In the Drawings:

Remarks

FIG. 1

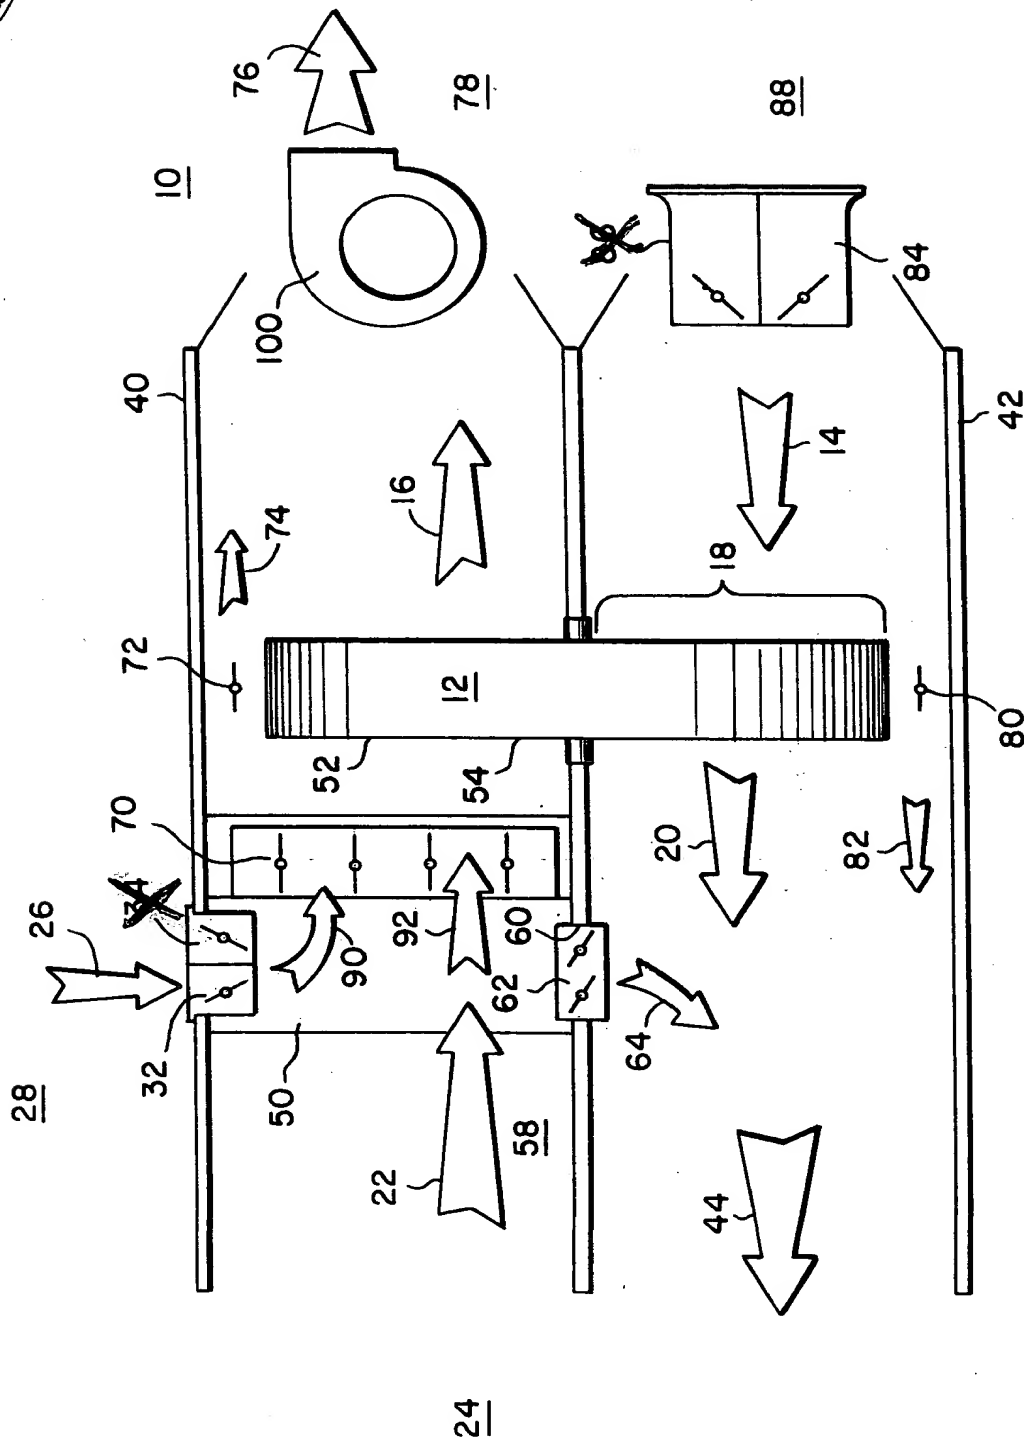
Drawing Objections in Numbered Paragraph 7:

Replacement sheet 1 has been submitted deleting reference numerals 34 and 86 and their respective lead lines. A highlighted version of the drawings is also attached to show the deletion of reference numerals 34 and 86 and their lead lines from Figure 1. Inasmuch as the Figures 2 and 3 are believed to clearly show the damper and sensor relative to reference characters 32, 34, 84 and 86, the deletion of these reference characters from Figure 1 is believed to resolve the drawing objection raised in numbered paragraph 7.

Please submit the amended Drawing Figure 1, Sheet 1, attached hereto in place of the Drawing Figure 1, Sheet 1, currently on file.
